NL-18-0039

Joseph M. Farley Nuclear Plant - Units 1 & 2
License Amendment Request to Revise Technical Specifications to Implement NEI 06-09,
Revision 0-A, "Risk-Informed Technical Specifications Initiative 4b,
Risk Managed Technical Specifications (RMTS) Guidelines"

Joseph M. Farley Nuclear Plant- Units 1&2

Attachment 1

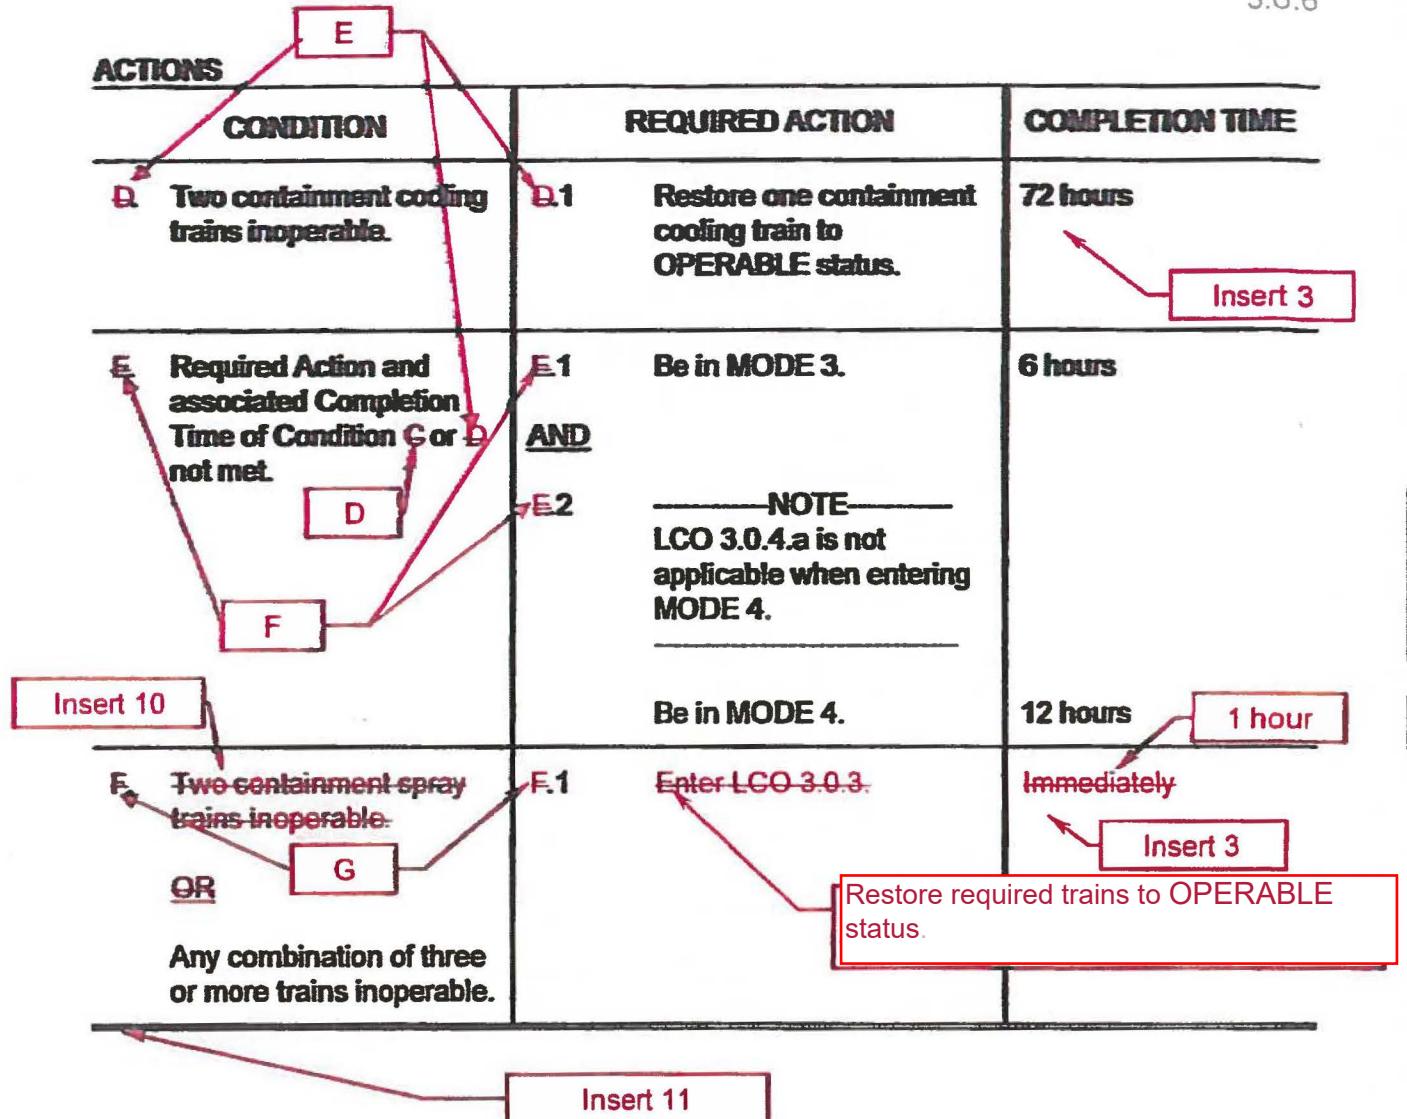
CONDITION	REQUIRED ACTION	COMPLETION TIME
A. One containment spray train inoperable. Insert 9	A.1 Restore containment spray train to OPERABLE status.	72 hours
B. Required Action and associated Completion Time of Condition A not met. or B	B.1 Be in MODE 3. AND B.2 —————NOTE————— LCO 3.0.4.a is not applicable when entering MODE 4. —————	6 hours 54 hours
C. One containment cooling train inoperable.	C.1 Restore containment cooling train to OPERABLE status.	7 days
D.

Bases Insert 1

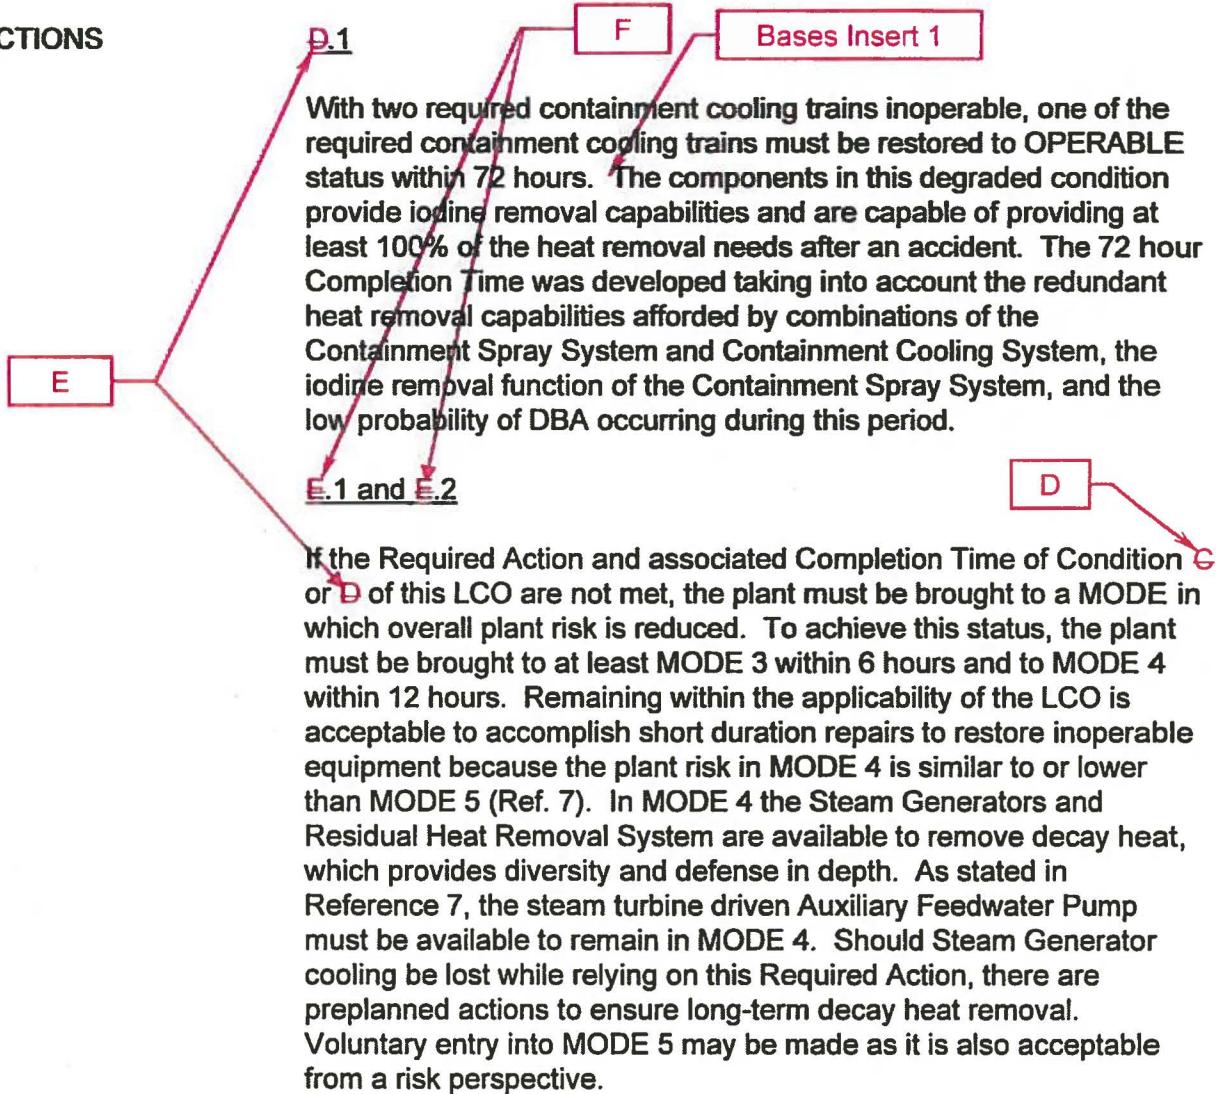
With one of the required containment cooling trains inoperable, the inoperable required containment cooling train must be restored to OPERABLE status within 7 days. The components in this degraded condition provide iodine removal capabilities and are capable of providing at least 100% of the heat removal needs. The 7 day Completion Time was developed taking into account the redundant heat removal capabilities afforded by combinations of the Containment Spray System and Containment Cooling System and the low probability of DBA occurring during this period.
